# LSC Responses to TIS Redline Comments

## Windermere Zone Change Traffic Impact Study PCD File No.: P229 & SP223 (LSC #S224091) January 25, 2024

**Table 2  
Trip Generation Estimate  
Windermere**

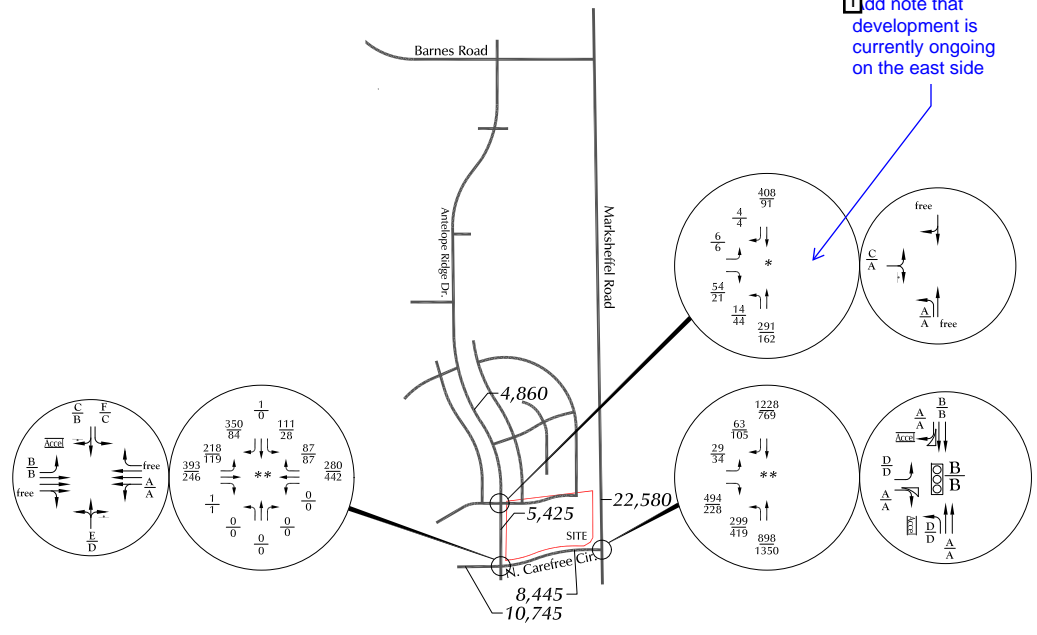
Replace or add approved trip generation for this area (40 SFD DU?) At this point Windermere Filing 1 traffic should be background (as implied by the table) and the previous study for the zone change is only informational.

Replace or add approved trip generation for this area (40 SFD DU?) At this point Windermere Filing 1 traffic should be background (as implied by the table) and the previous study for the zone change is only informational.

Author: Kirstin Ferrin Subject: Sticky Note Date: 6/11/2024 9:57:36 AM  
LSC Response: Revised as requested.

Figure 4  
 Existing Traffic,  
 Lane Geometry, Traffic Control  
 and Levels of Service  
 Windermere Zone Change (LSC #S224091)

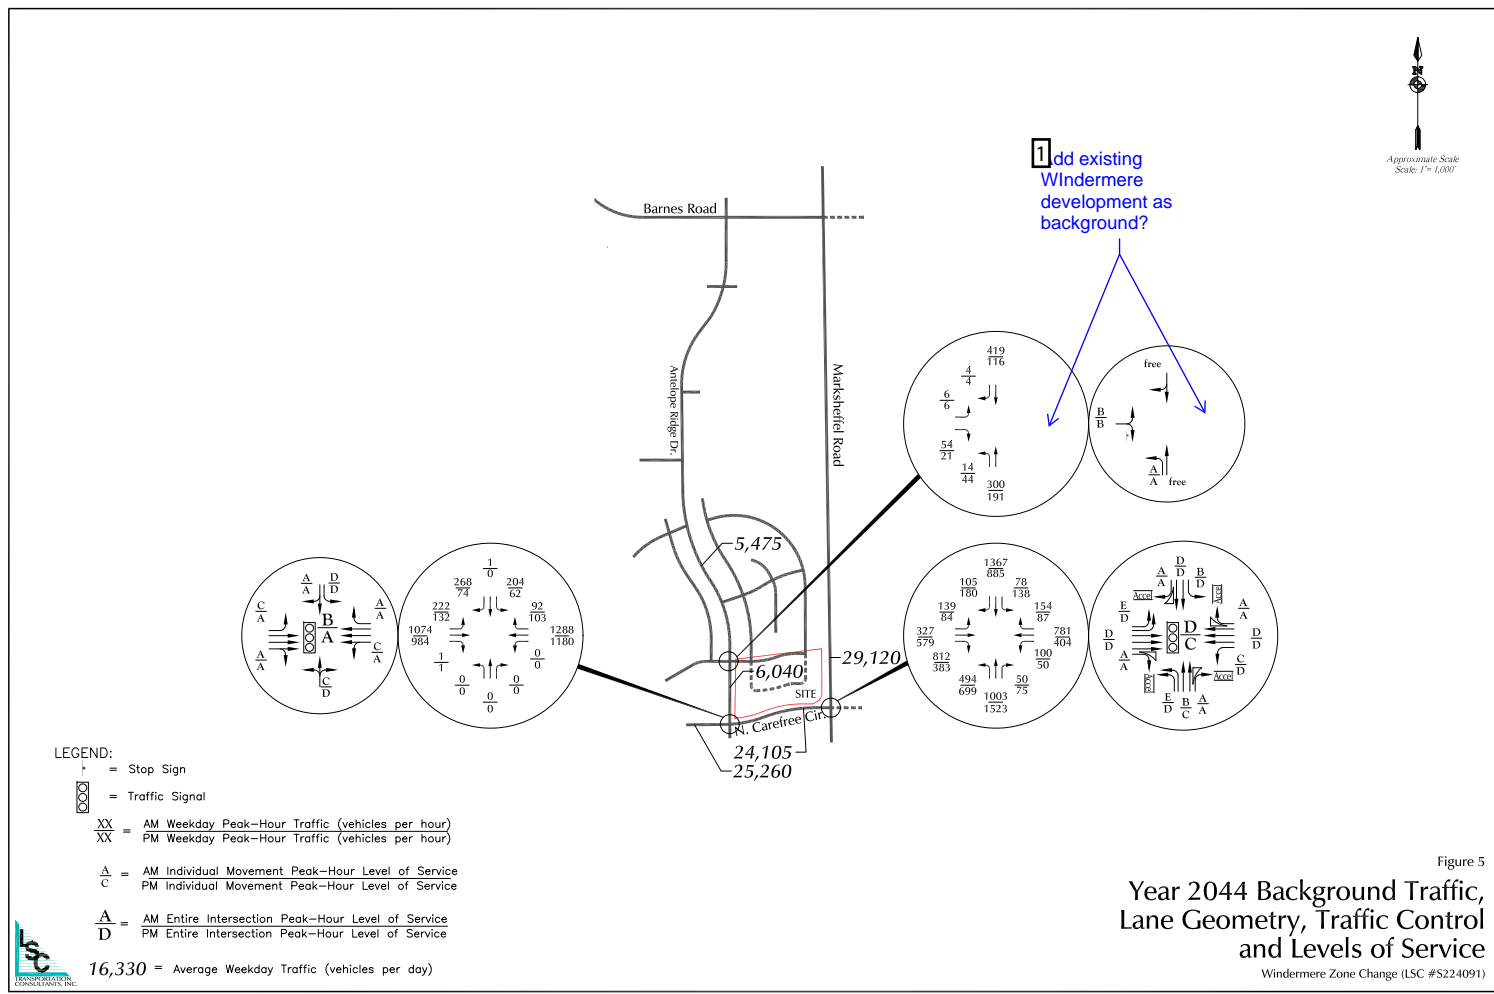
Add note that development is currently ongoing on the east side

Author: Kirstin Ferrin Subject: Sticky Note Date: 6/11/2024 9:57:42 AM  
LSC Response: Revised as requested.

Figure 9  
**Short-Term Total Traffic, Lane Geometry, Traffic Control and Levels of Service**  
 Windermere Zone Change (LSC #S224091)

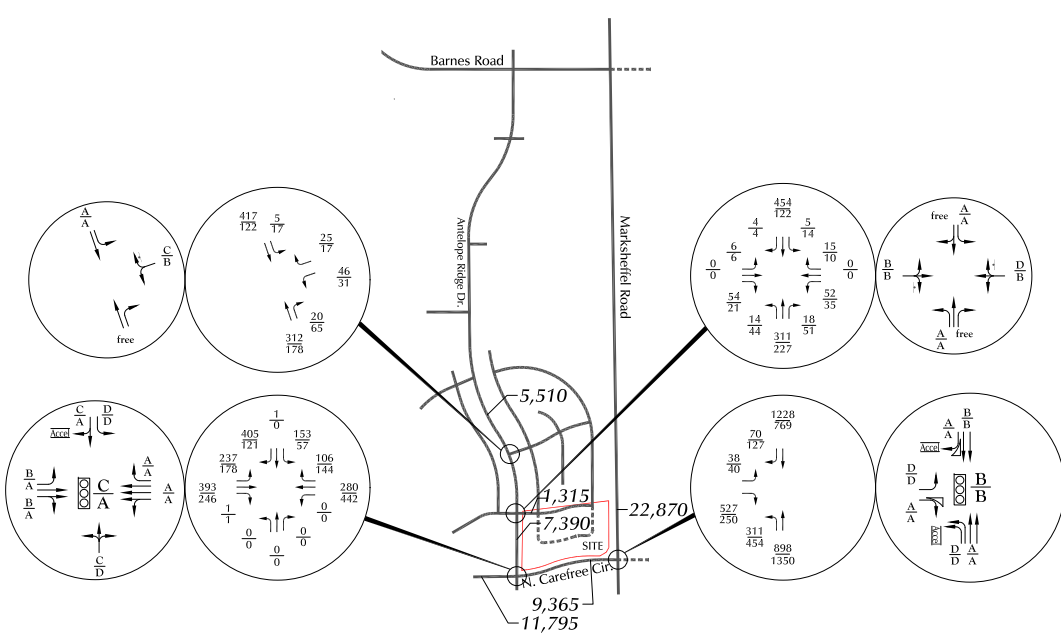
Please indicate year of short-term.

LSC Response: The additional information has been added as requested.
